The Banks – Phase 3C
Public Infrastructure Development
Bid Package #2 – Lot 28 Park & Garage
January 13, 2022
THP #98090.40

ADDENDUM #2

1 ENLARGED PLAN - STEPPED BENCH @ LOWER WALK
A513 1/4" = 1'-0"

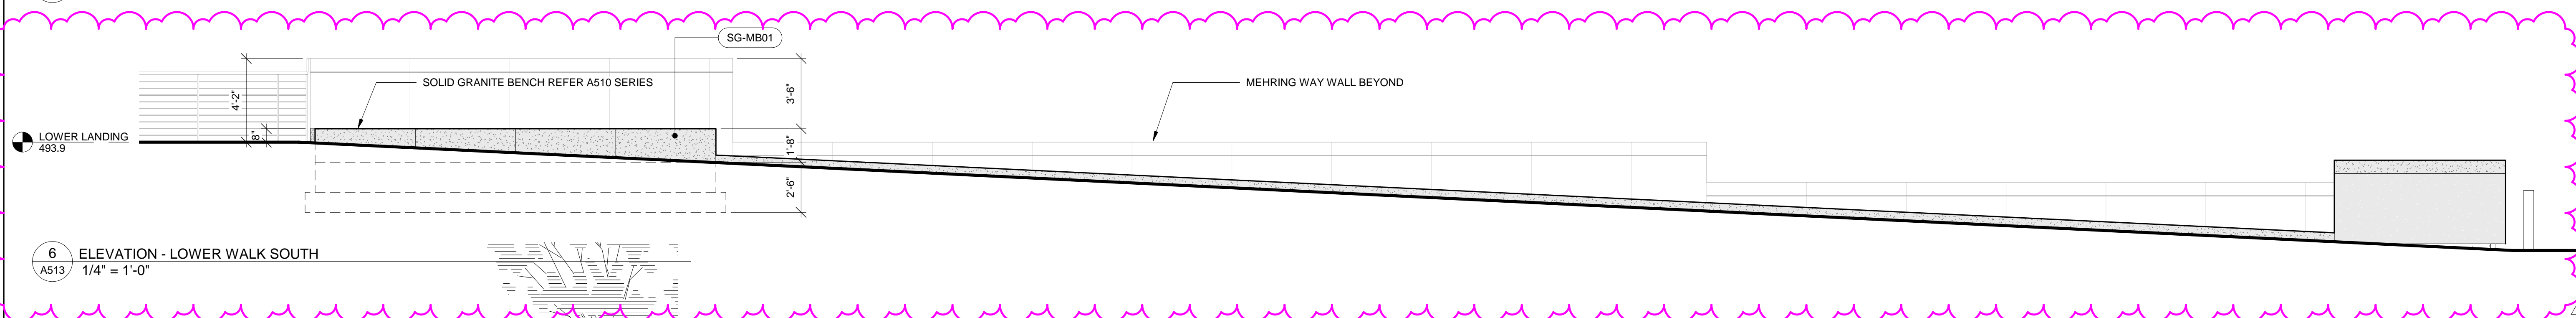
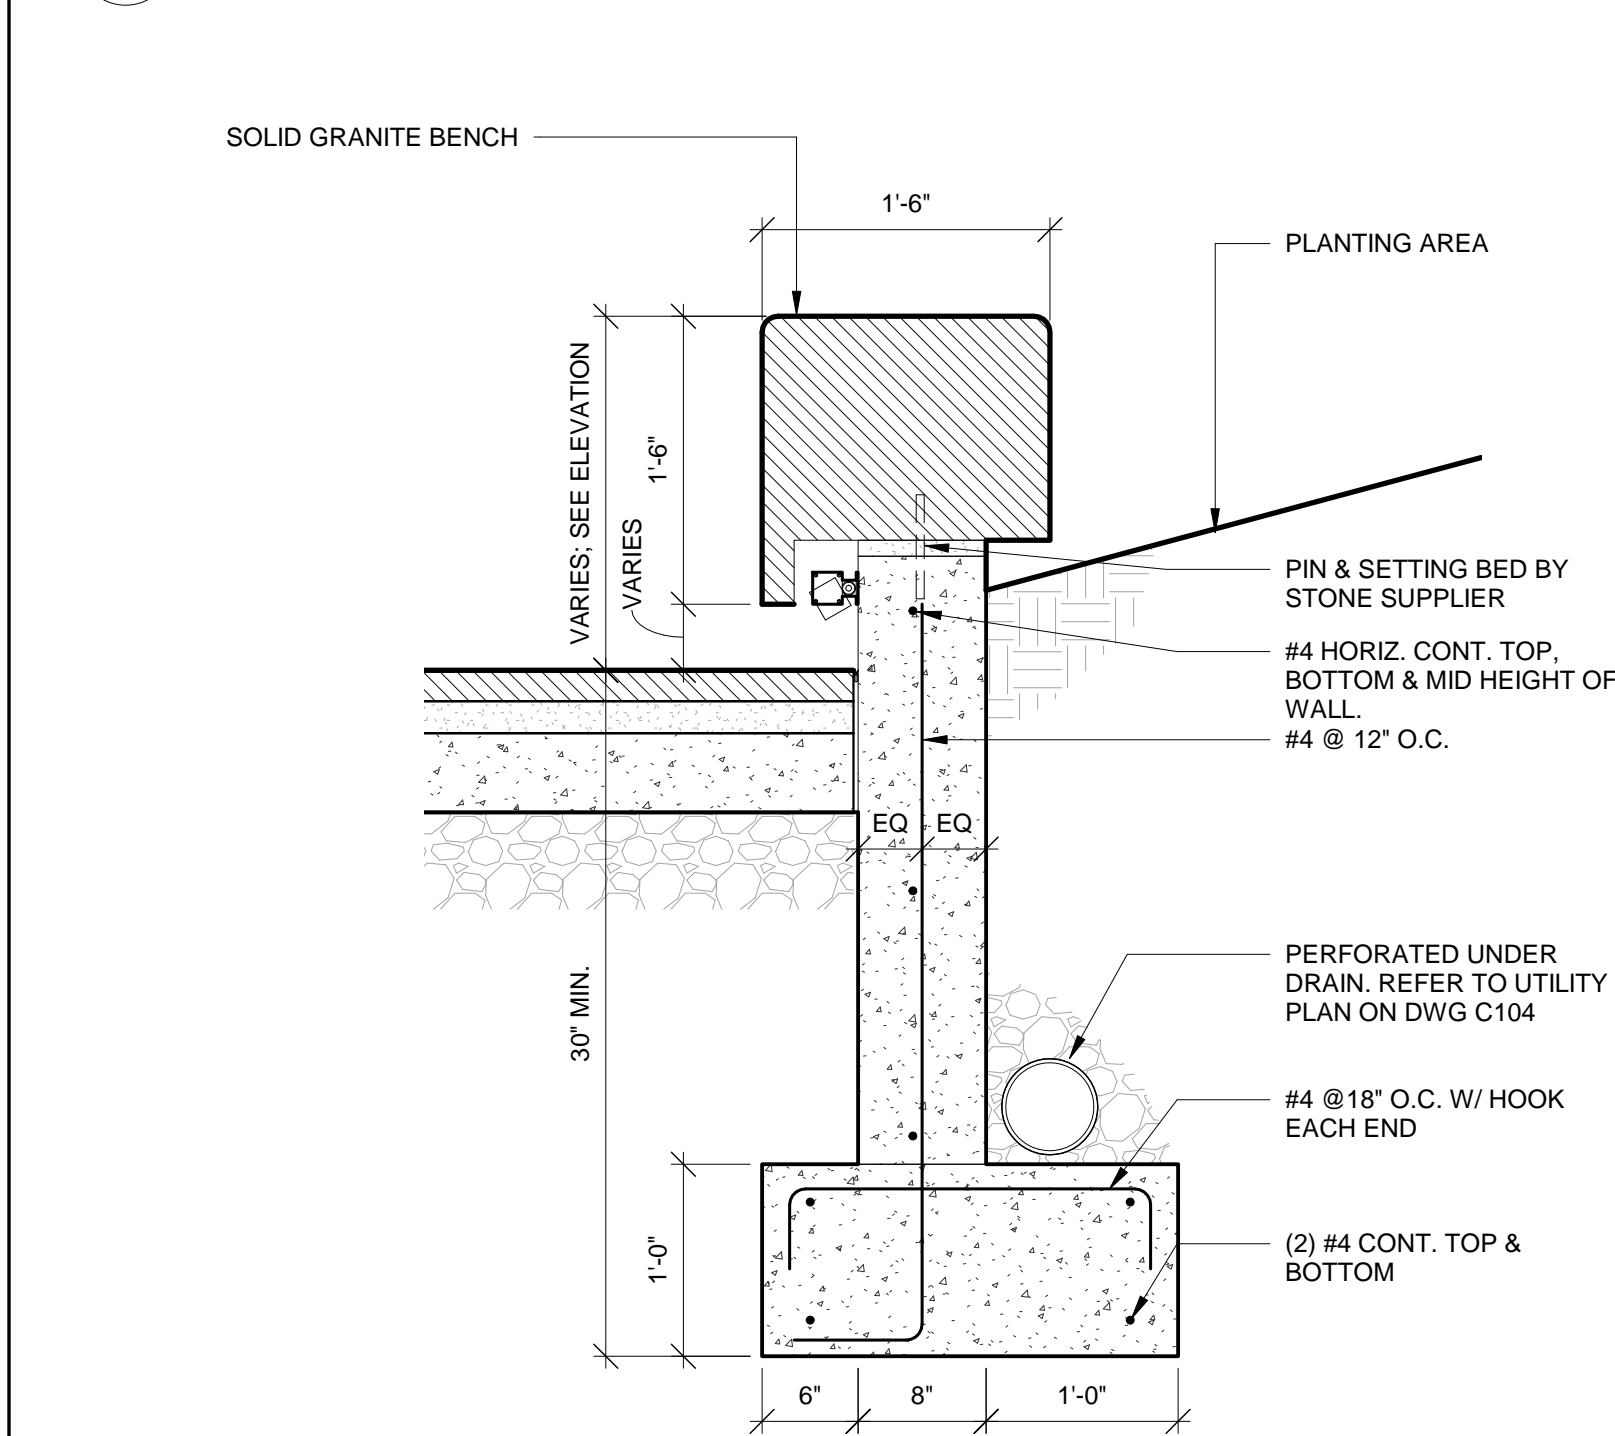
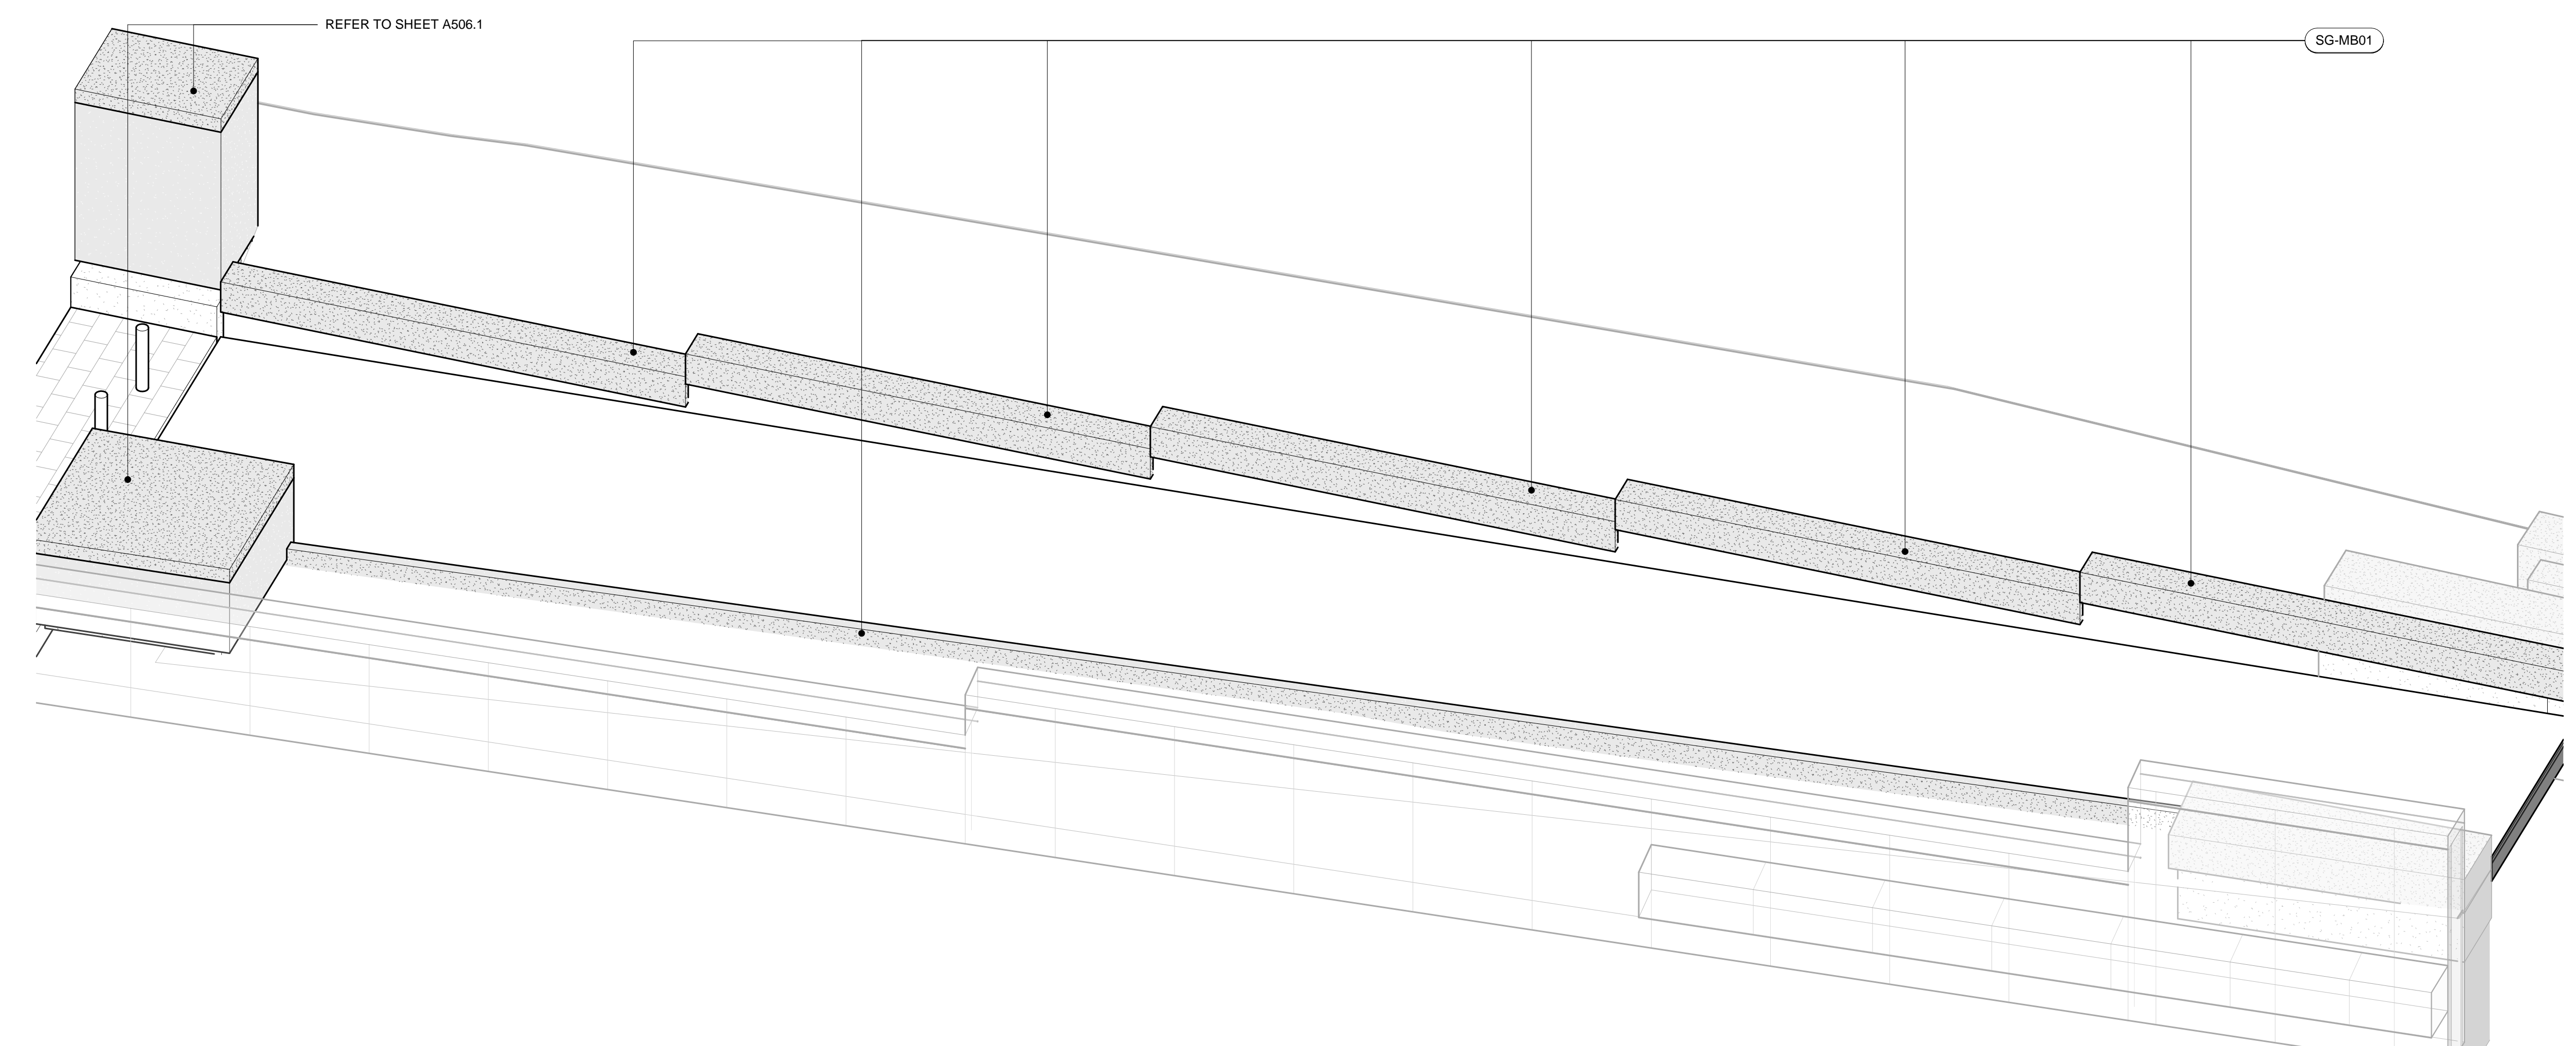
- Added new elevation
- Added notes & elevation marker

3 PARK LEVEL PLUMBING PLAN (LOT 23)
SCALE: 1/8" = 1'-0"

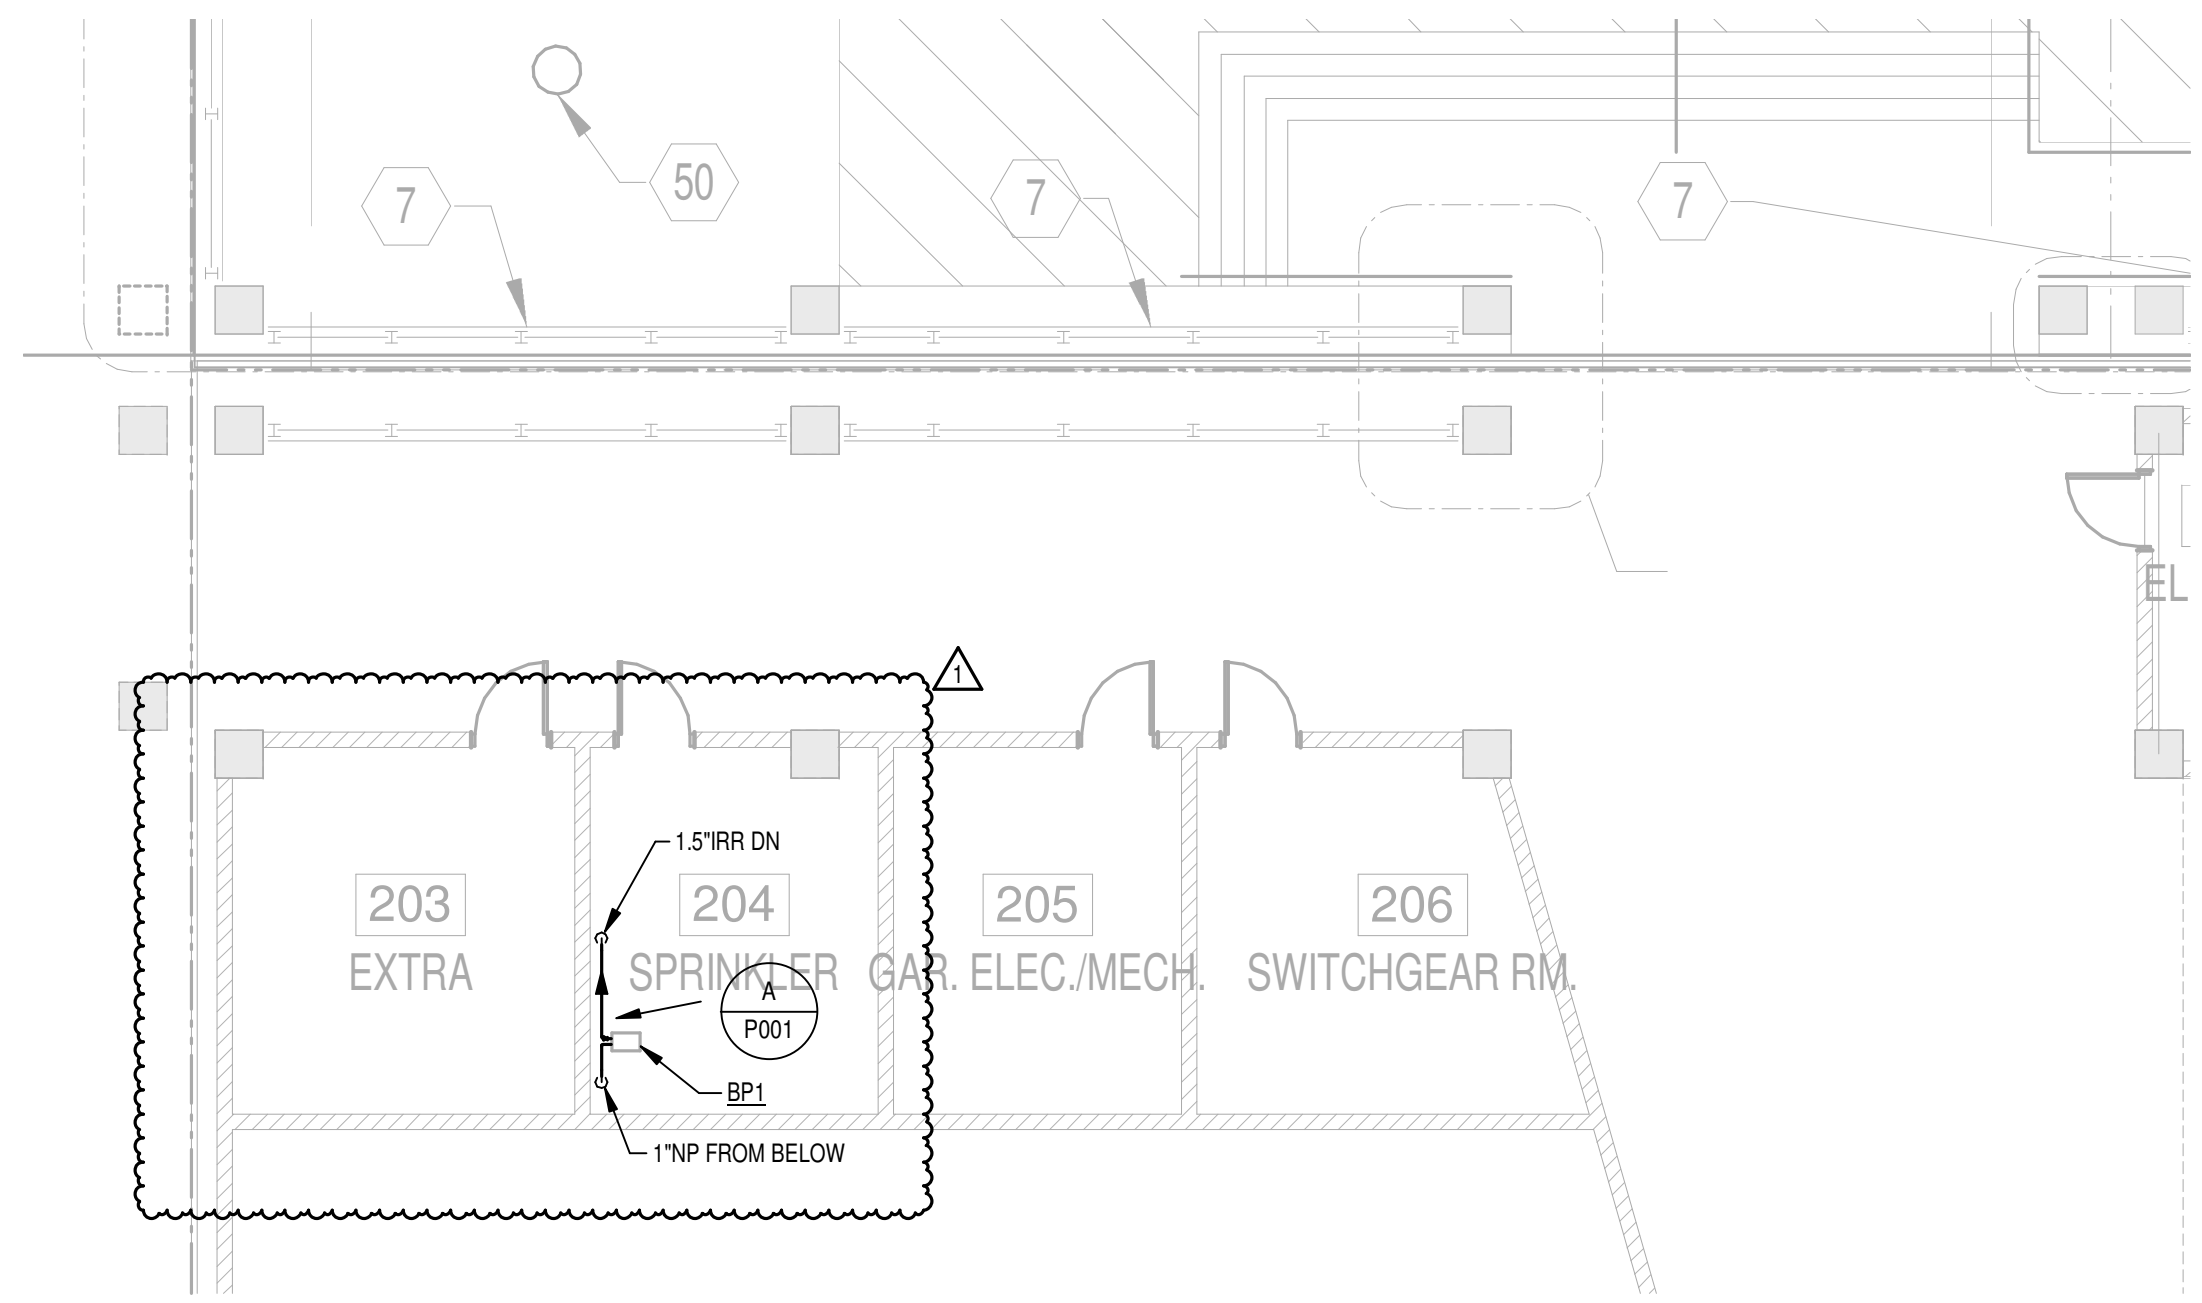
- Lot 23 Plan: Relocated Booster pump assembly location from "Extra Room" to "Sprinkler Room". Revised pipe sizes.
- Lower Level Plan:
 - Removed large portion of new 1.5" NPW piping extending from Lot 23 connection to the east, to supply riser location. Due to revised pressure and flow requirements, irrigation supply can now be tapped from adjacent existing 1" NPW main as shown.
